Our Ref: 17-18/L000814
CRC Ref: MCUC2385/2017
Date: 8 January 2018

RE: RESPONSE TO INFORMATION REQUEST IN RELATION TO A DEVELOPMENT APPLICATION FOR MATERIAL CHANGE OF USE FOR 'MULTI-UNIT HOUSING' ON LAND AT 14 MUDLO STREET, PORT DOUGLAS, MORE PARTICULARLY DESCRIBED AS LOT 919 ON PTD 2092

22 December 2017
LMB-01 D101

RE: Information Request _14 Mudlo St – Items 1 and 4

Fig Tree Villas

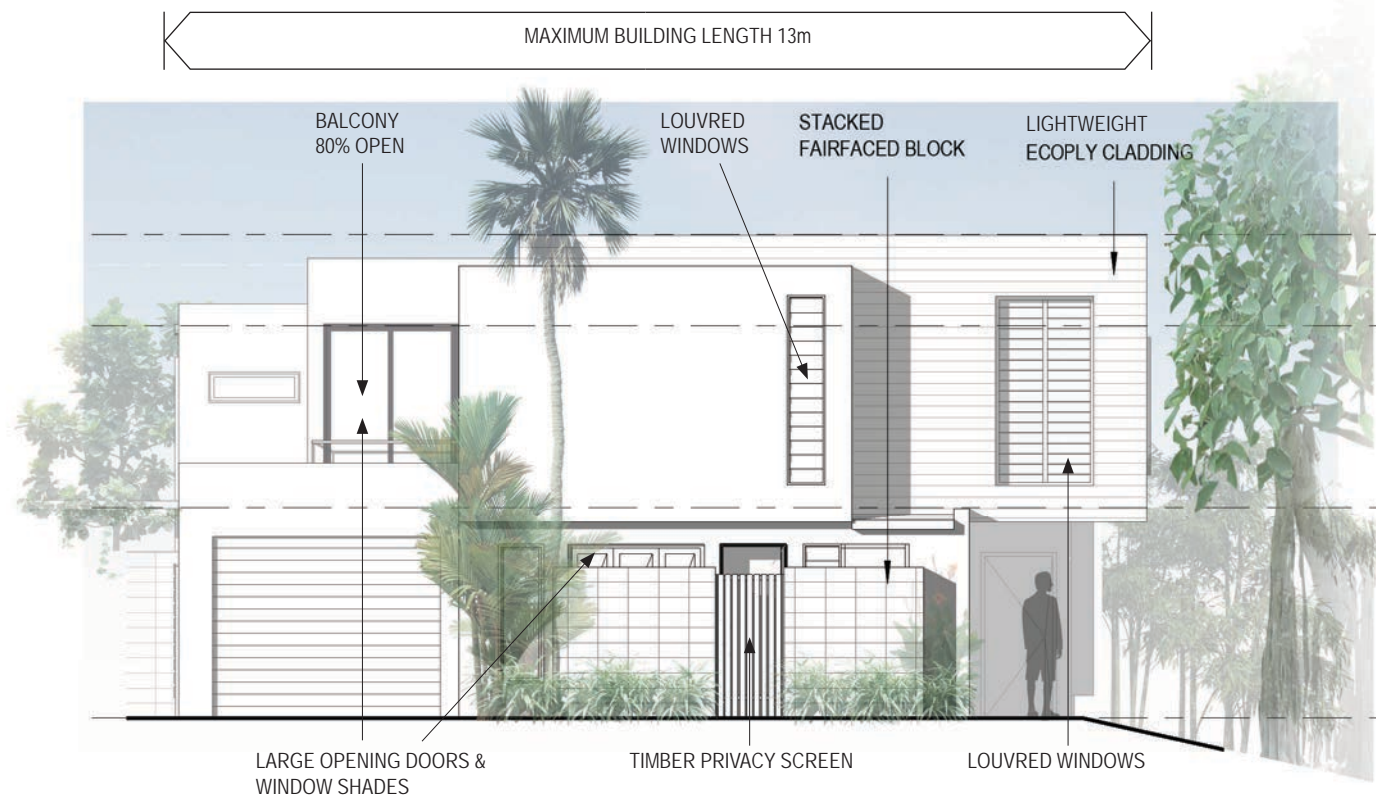
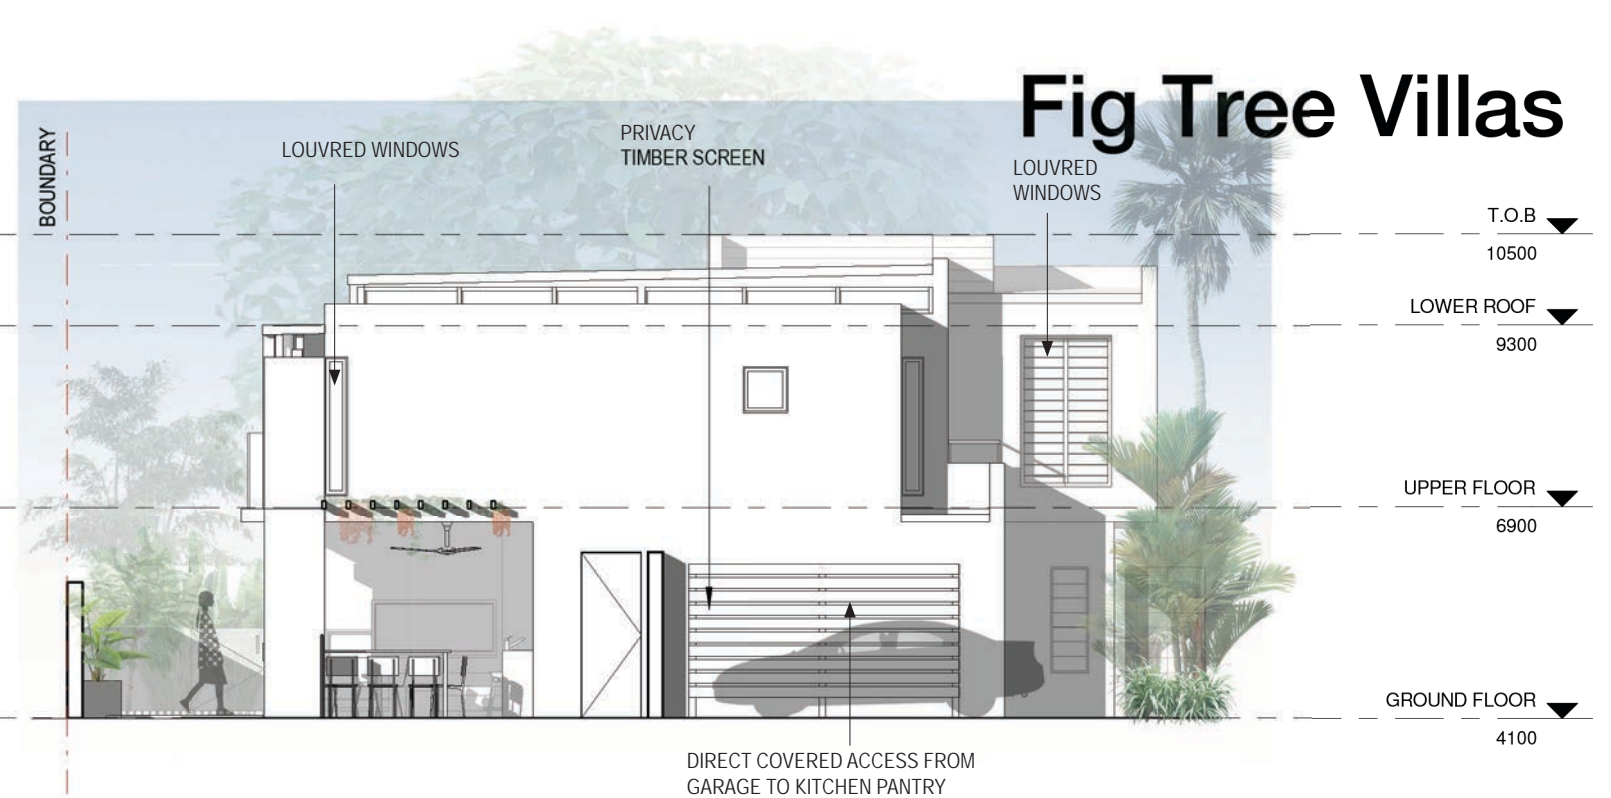
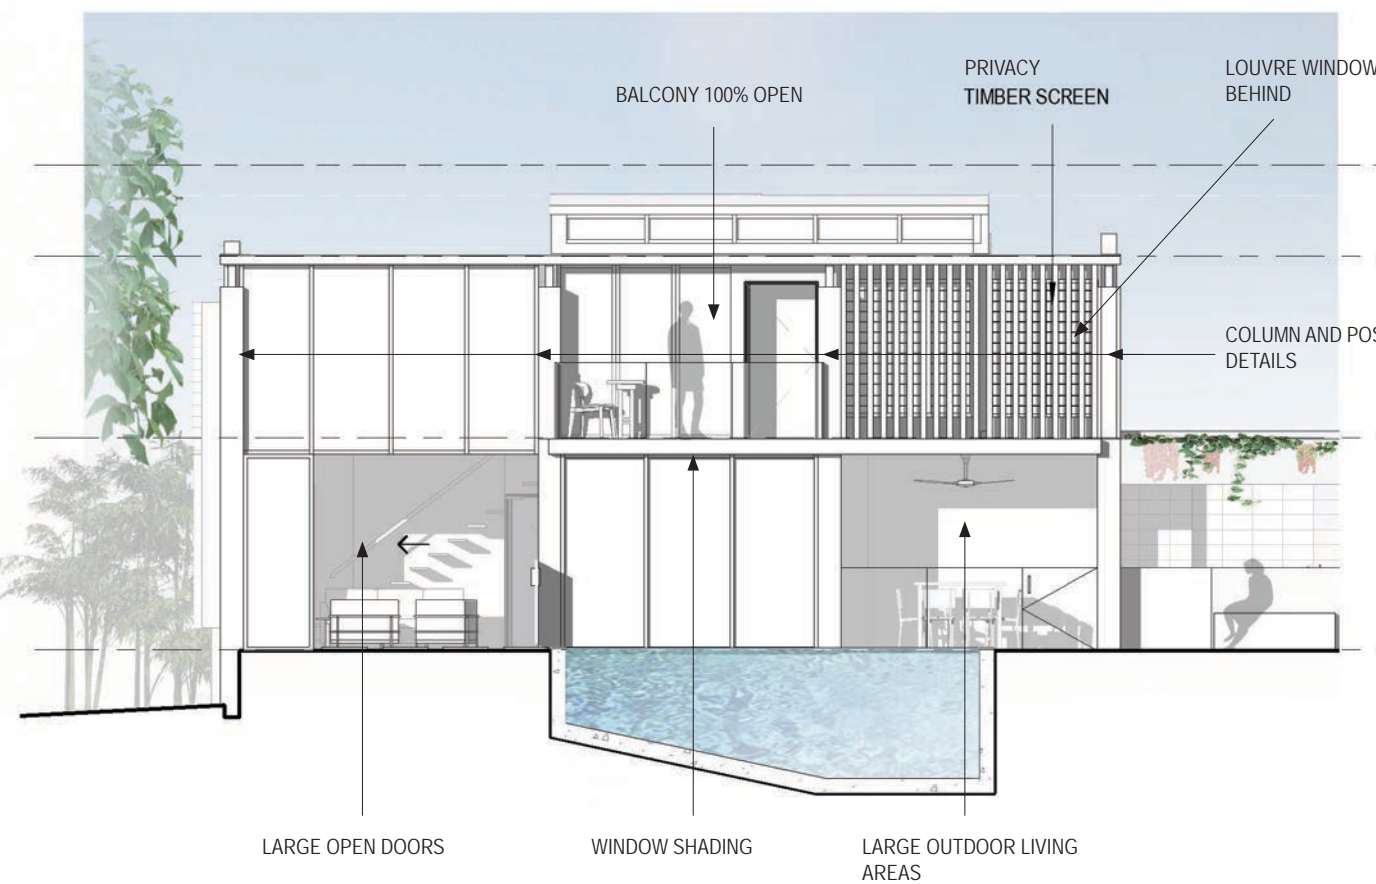
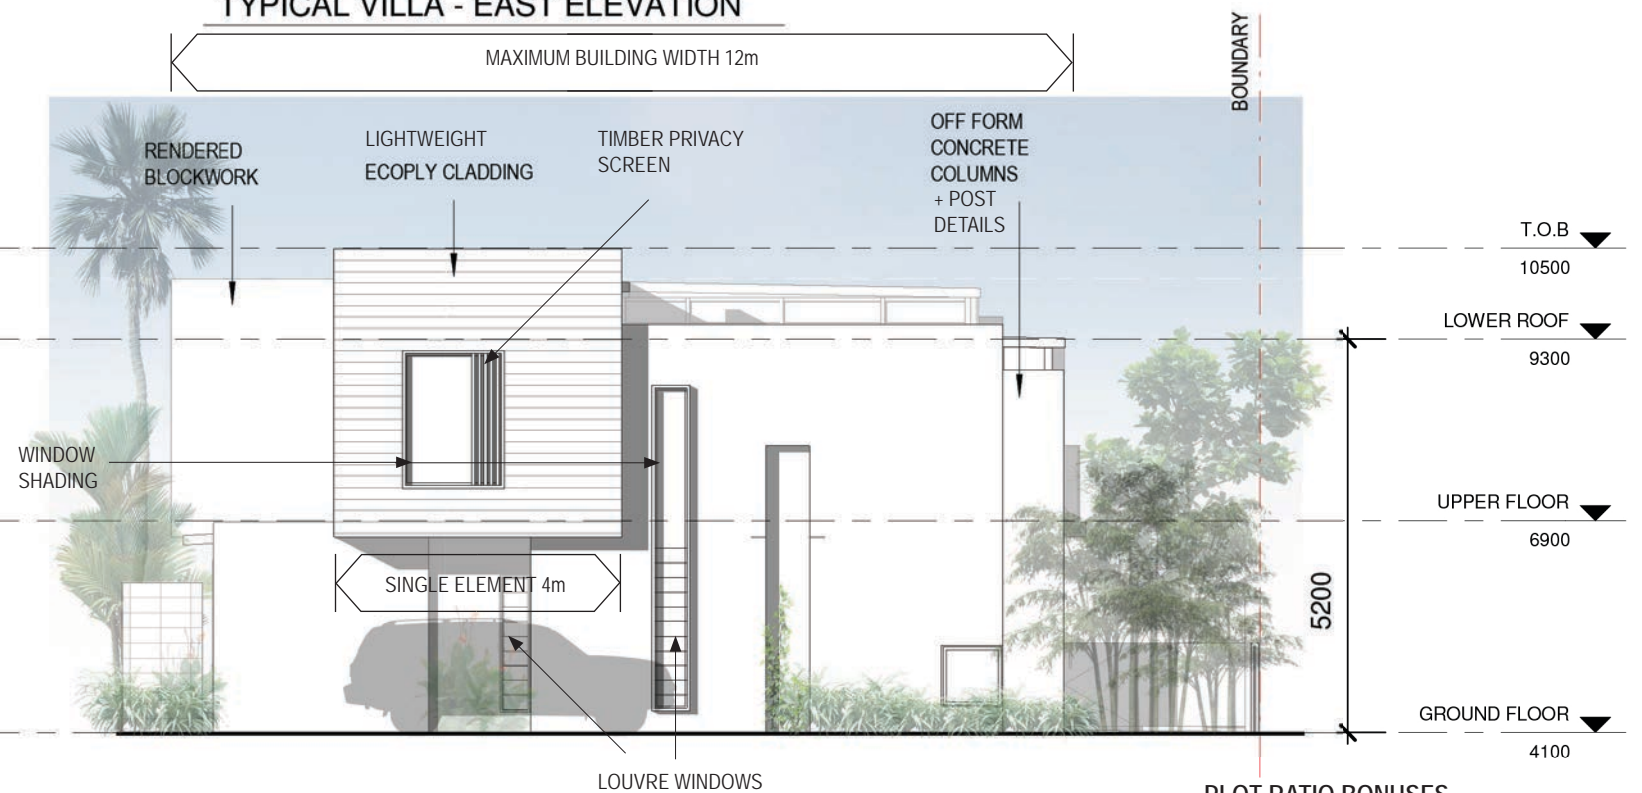
4. *Demonstrate how the proposal complies with Planning Scheme Policy No 2 – Building Design and Architectural Elements. It is noted that the proposed buildings lack tropical design features.*

The following references the specific elements noted in the Policy 2 schedule illustrated on the elevations of the proposed development, drawing LMB01 DA.04b

A large open balcony is provided in front of the upstairs living area. A smaller open balcony is provided to Bed 4 facing the internal road elevation, providing contrasting light and shade to this semi-public elevation, as envisioned by the Policy.

Deep frame awning shading devices are provided to windows on the west elevation, from the lounge tall louvred glass and to the Bed 3 windows facing the street. These frames provide shade to the deep reveal of the windows and can be readily seen on the 1:100 ground and first floor plans. Overhangs are provided to the vast majority of windows however only partial compliance is sought here.

Lightweight posts are provided at the tops of the structural concrete columns as shown in the southern elevation. Here the roof overhang sits atop these lightweight posts in juxtaposition to the structural concrete columns below reinforcing the lightweight nature of the roof structure over.

Various timber screens are indicated throughout the project and a propensity for use of traditional glass and aluminium louveres as indicated to all elevations.

Specific plot ratio bonuses applicable to the provisions of the tropical design features are noted in the summary plot ratio bonuses table on the elevation drawing LMB01 DA.04. It can be seen that 0.35 bonuses have been achieved where only 0.11 are required.
